**Wickenburg Downtown Flooding Hazard
Mitigation Project
(FCD #2006C018)
CLOMR
FEMA Case No. 07-09-0738R**

**Response to
FEMA Review Comments of
April 17, 2007**

IN REPLY REFER TO:
Case No.: 07-09-0738R

Comment #9

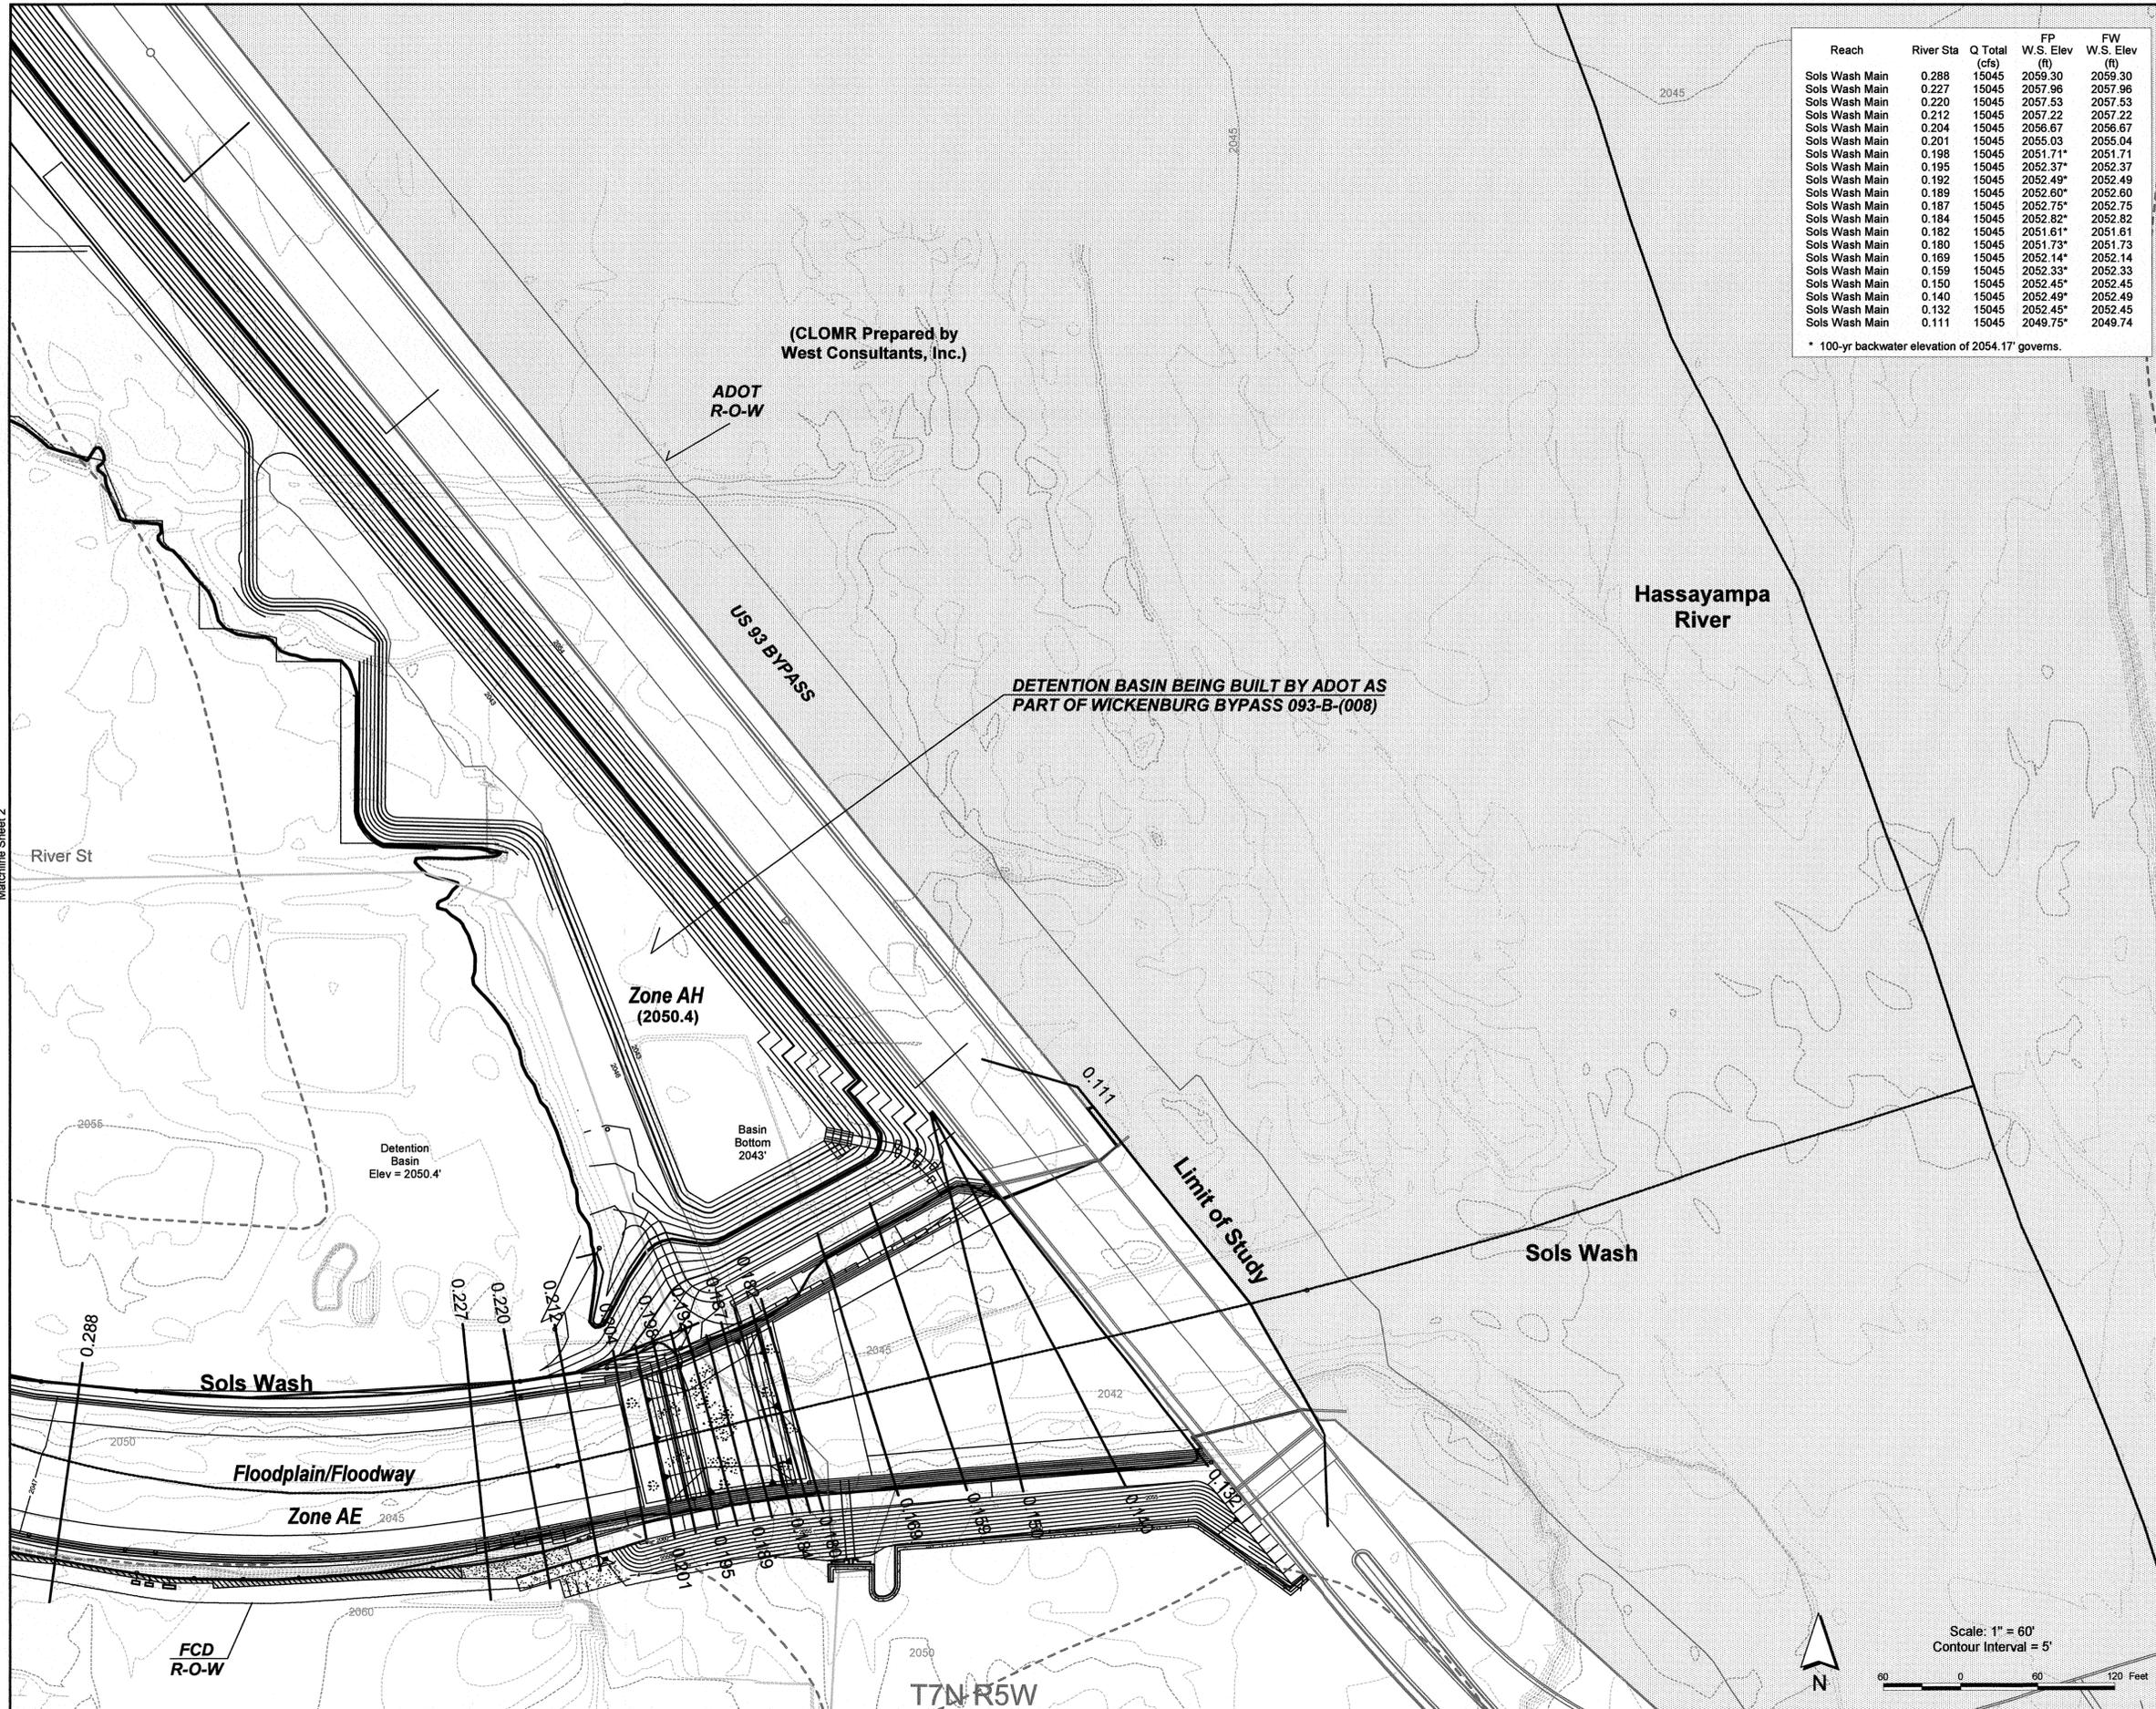
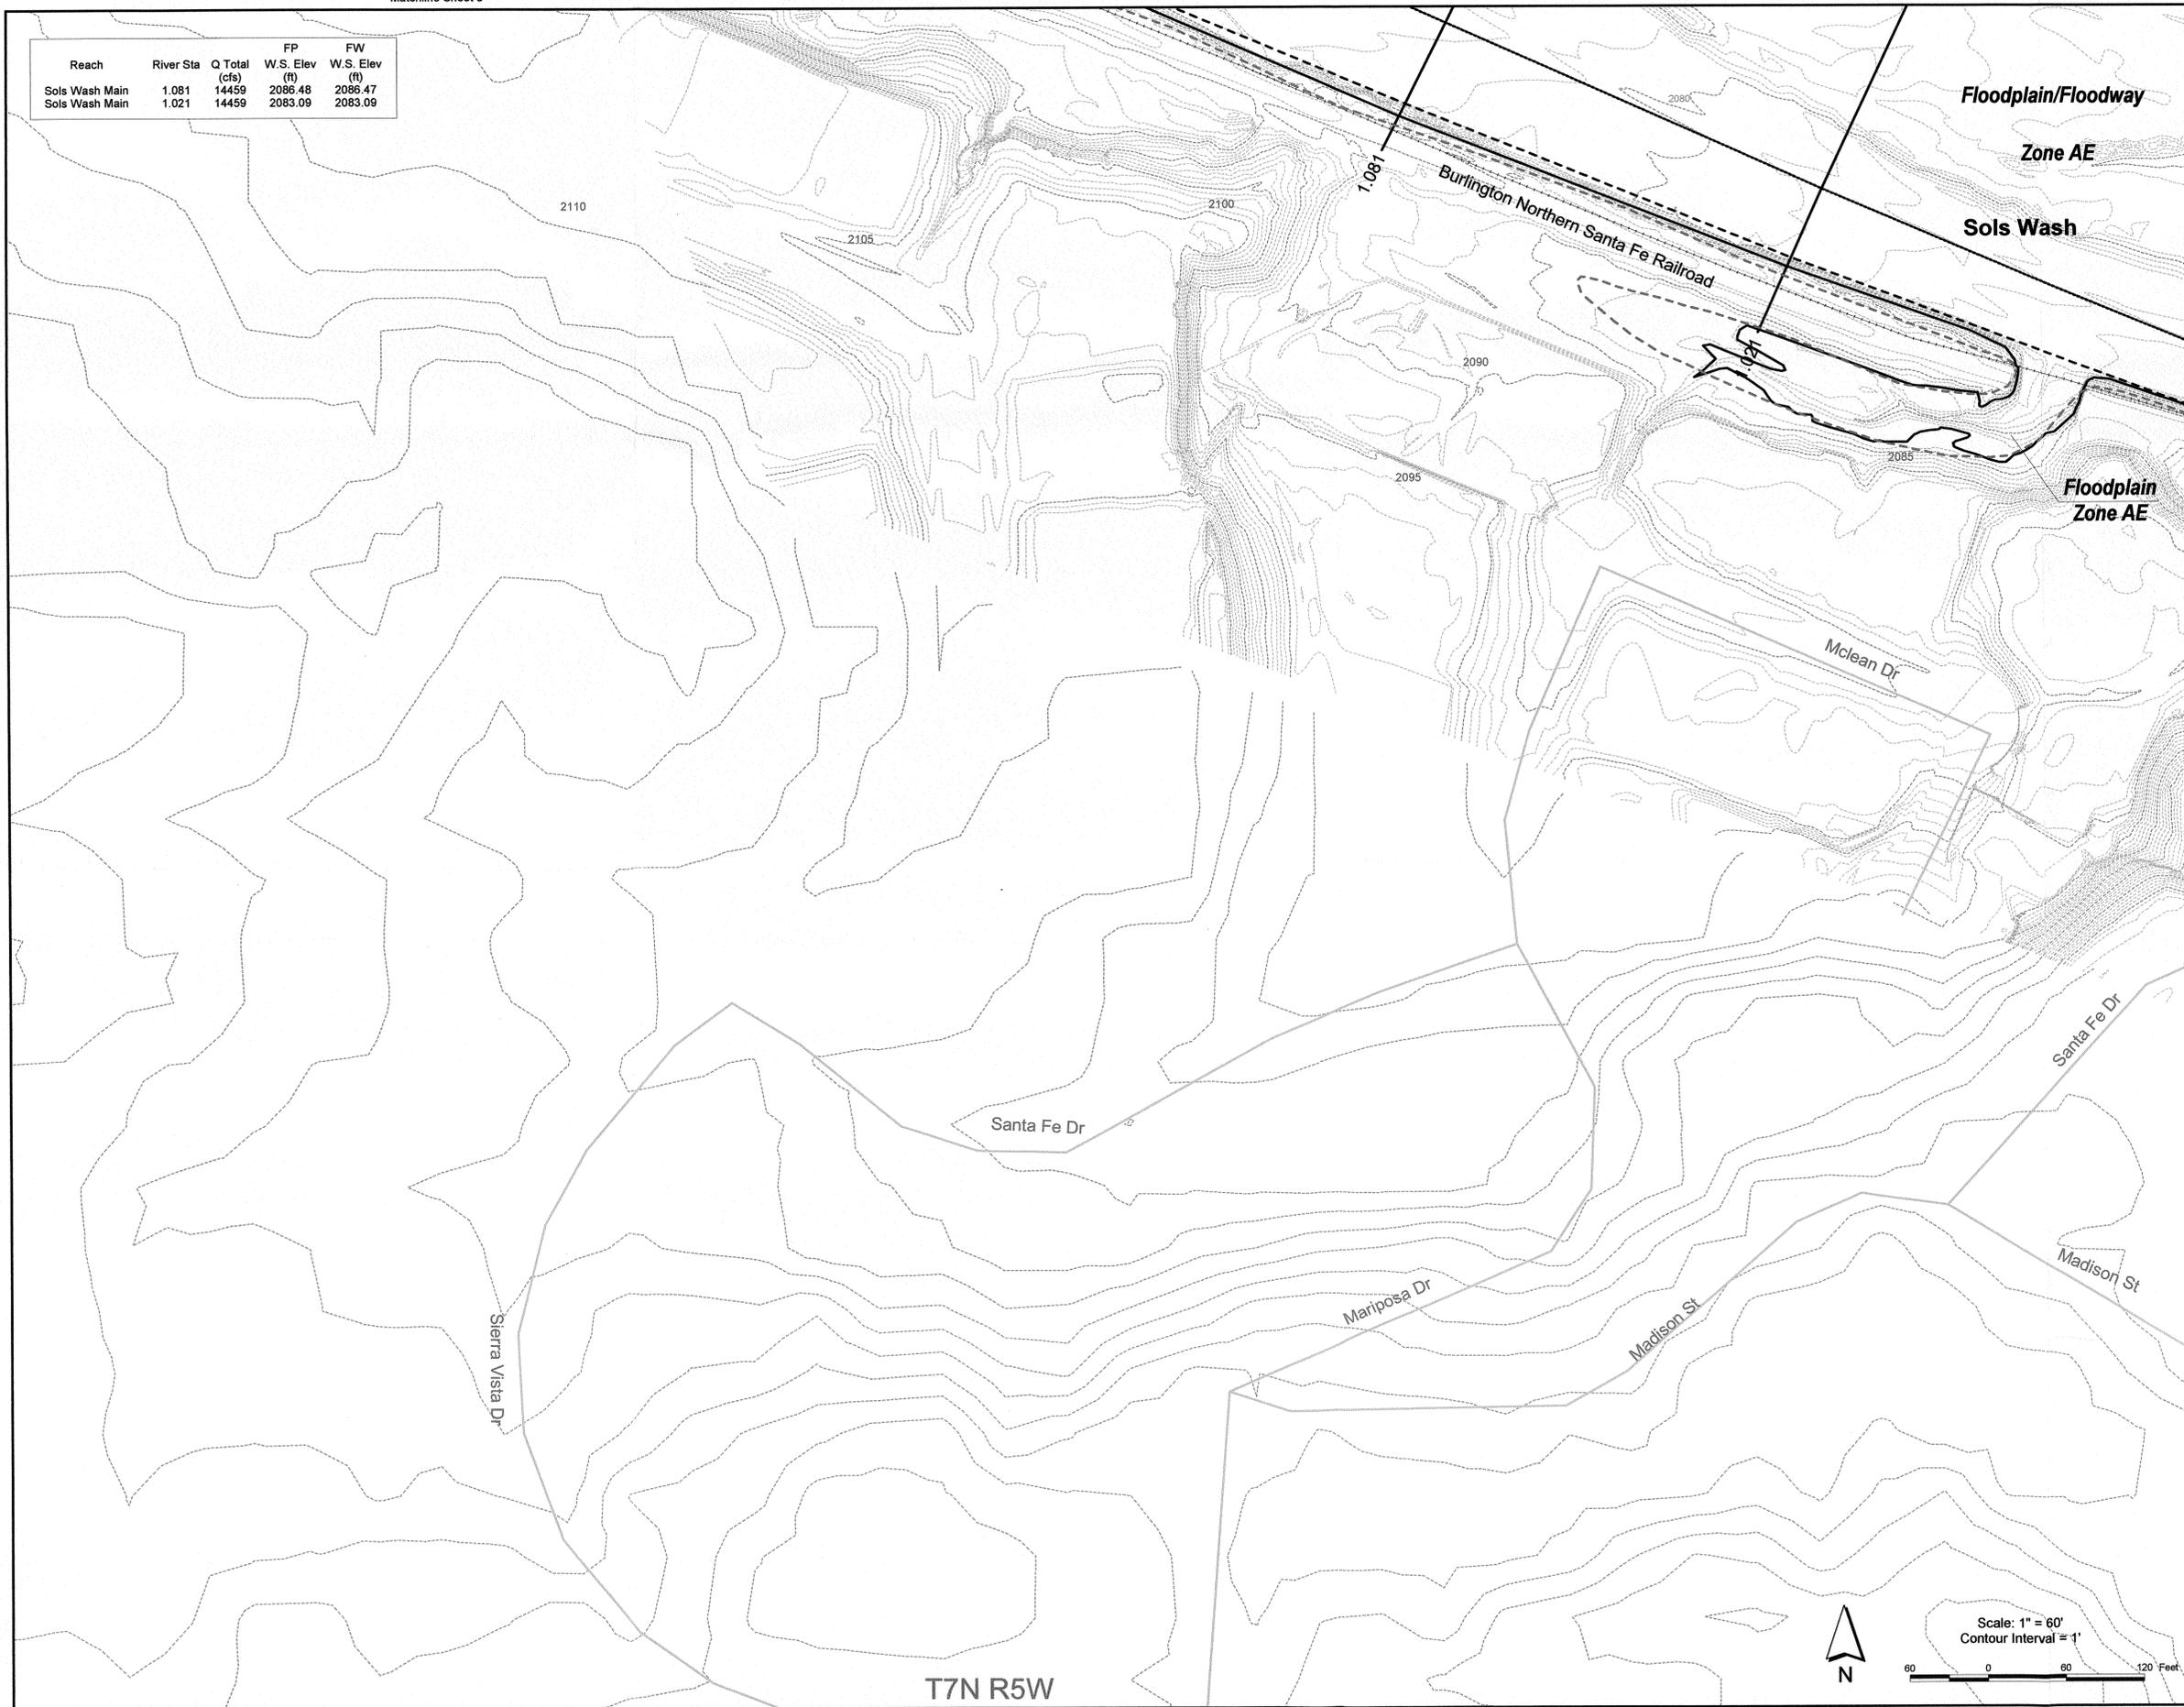
9. The above-mentioned topographic work maps do not provide essential information required to complete our detailed review of this request. Please provide the following information, which was omitted from the submitted topographic work maps.

- (a) Boundary delineations of the currently effective base floodplain and floodway
- (b) Boundary delineation of the existing conditions base floodplain
- (c) Existing conditions topographic contour information, including the topographic information that has been altered by the existing floodwall and Goldmine Village improvements
- (d) Proposed conditions topographic contour information, including topographic information that will be altered by the proposed levee, which can be used to verify the boundary delineation of the base floodplain
- (e) Please submit both a hard copy and a digital copy of all work maps

9. Revised work maps are enclosed.
 - a) The effective floodplain/floodway limits have been added to the workmaps.
 - b) The existing conditions floodplain was not studied under this project as the overall intent of this project is to channelize the Sols Wash floodplain, thereby, greatly reducing the limits of the floodplain. Based on topographic information developed for this study and that for the original FEMA study for Sols Wash, however, there is no reason to expect any significant difference between a current "existing" conditions floodplain and that of the effective study. The only exception to this is in the north overbank area where flows on the west side of Tegner Street are likely to cross over the roadway into the north overbank area on the east side of Tegner St. This is not reflected in the effective delineation even though the original FEMA study workmaps indicated that flow elevations were such that 100-YR flows might overtop Tegner St. An existing conditions study, which addressed the flows overtopping Tegner, was performed under the Goldmine Village request for a CLOMR, submitted to and approved by FEMA.

per the CLOMR. Some additional fill is required on the site to meet the CLOMR geometry. The Wickenburg Downtown Project will provide that fill. The proposed grading for the property has been added to the workmaps. The existing conditions topo shown on the submitted work maps is as the site currently exists today. Pre-fill topographic data is available in the Goldmine Village CLOMR. Please note: there is no existing floodwall on the Goldmine Village property.

- d) Proposed topographic contours have been added to reflect the proposed fill on the Goldmine Village property. Additional contours have been added where practical. Please note, in areas of vertical floodwalls, contours cannot be shown. In these areas, please refer to the cross section plots. Some revisions, to correct some minor discrepancies, have been made to several of the cross section sheets since the original submittal. Please see the revised plots in the design plan set.
